The Columbia Historic Zoning Commission will meet on Wednesday, September 18, 2024 at 4:00 PM in Council Chambers on the basement level of City Hall, 700 N. Garden Street, to consider the following:

CITY OF COLUMBIA TENNESSEE
HISTORIC ZONING COMMISSION
STAFF REPORT

CA 24-0380

PROJECT DESCRIPTION: Certificate of Appropriateness request for exterior alterations and additions.

Figure 1 Rear Elevation

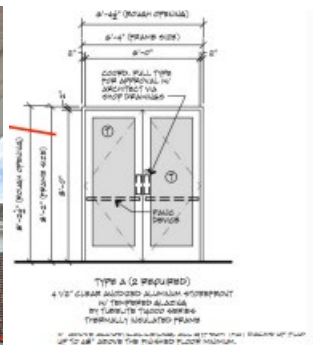
HZC References: 5.21, 5.22, & 7.19

Proposal: replace double doors with Anodized Aluminum Storefront doors with finish to match aluminum windows at rear and secondary elevations, and replacing the existing light with proposed pendant lighting is in compliance with HZC Guidelines 5.21, 5.22, & 7.19.

Figure 2 Secondary Elevation, northwest

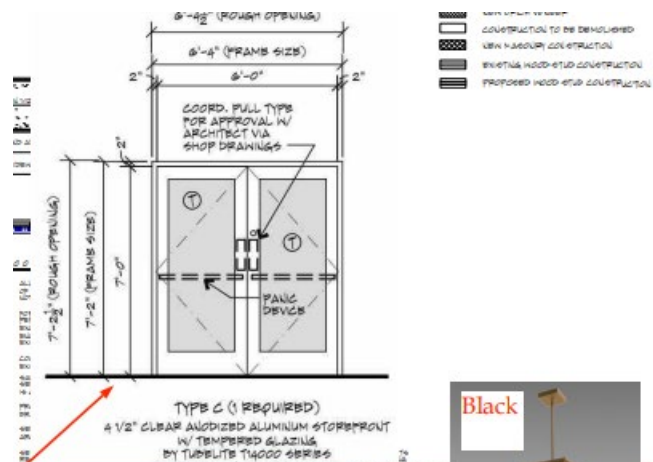
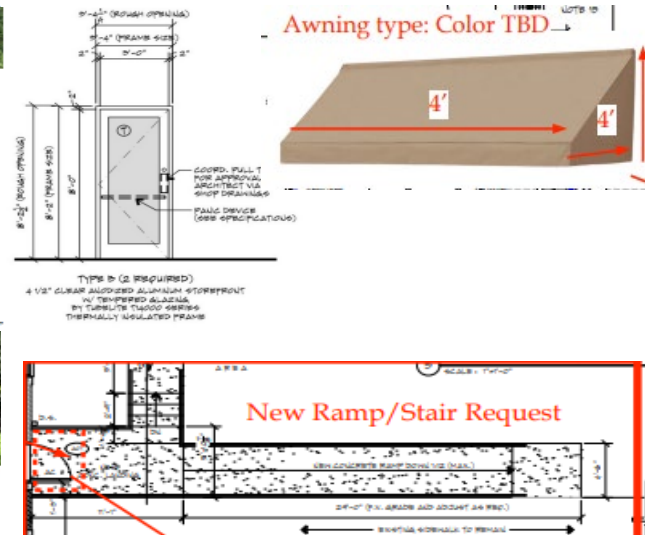
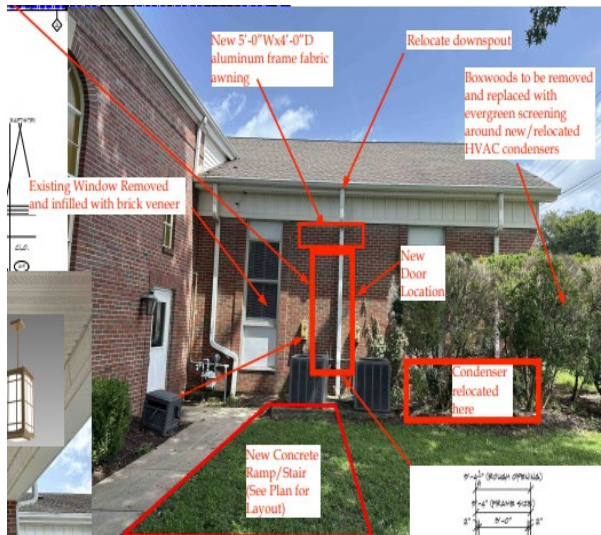
HZC References: 5.21, 5.22, 5.23, 7.20, & 7.22

Proposal: create new opening and installation of Anodized Aluminum Storefront door, infill existing window with brick veneer, install aluminum frame fabric awning over proposed new door, relocate condenser units, and install ramp/stair addition is in partial compliance with the HZC Guidelines. See staff comments below.

The proposed door materials, Anodized Aluminum, is a compliant substitute material. The proposed new opening is a secondary location, but is not located on a minimally visible side or rear elevation. **Landscape treatment may need to be suggested to buffer from Secondary Frontage.** Proposed infill of existing window opening with like material (brick veneer) is compliant to standards, however, the Guidelines calls for **avoidance**. If permitted, the standard for compliance is to **recess the infill in order to maintain the outline of enclosed opening**. The proposed awning size and style are compliant with the standards. **Awning is to be installed no less than 7.5 foot above sidewalk.** The condenser units previously existed at this elevation. The Guidelines require new installation to be **installed at the rear**.

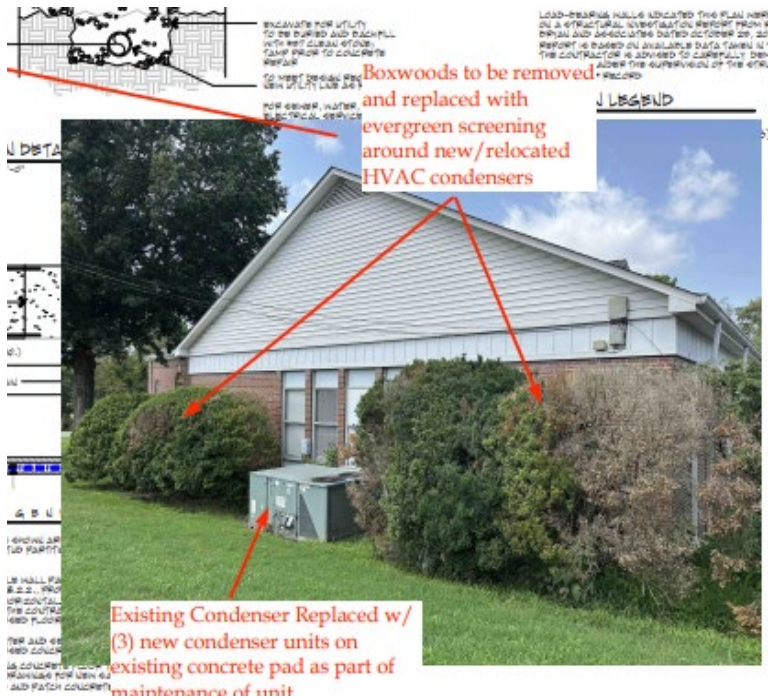
Relocation of the existing is not subject to this standard, however, **landscape treatment should be suggested to buffer from Secondary Frontage.** The ramp is proposed to be located at a secondary entrance adjacent to the face of the building, however, it also runs parallel to the Secondary Frontage. The Guidelines require **minimization of its prominence. Landscape treatment should be suggested here as well to buffer from Secondary Frontage.**

Applicant suggests that evergreen landscaping will replace the boxwoods that are proposed to be removed. This location is situated directly adjacent to the Secondary Frontage. **Landscape screening may need to be suggested as a buffer to the ROW, located specifically between units and ROW.**

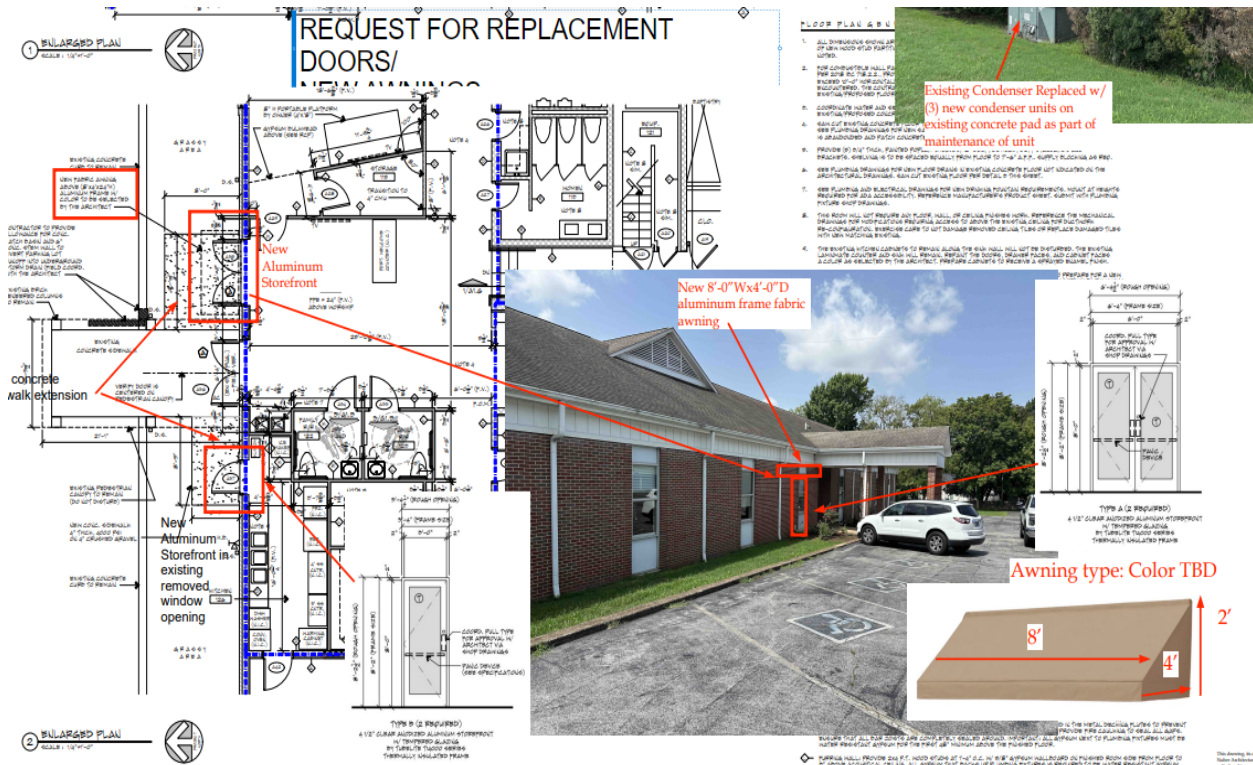
The proposed additions of the doors noted in the above elevation meet the materials and placement standards as outlined in the Historic Guidelines, Anodized Aluminum Clad as a substitute material and both are located at the rear elevation. The proposed awnings at both locations are also compliant. **The Historic Design Guidelines require that awnings be installed no less than 7.5 feet above the sidewalk, and that all awnings at multiple locations match.**
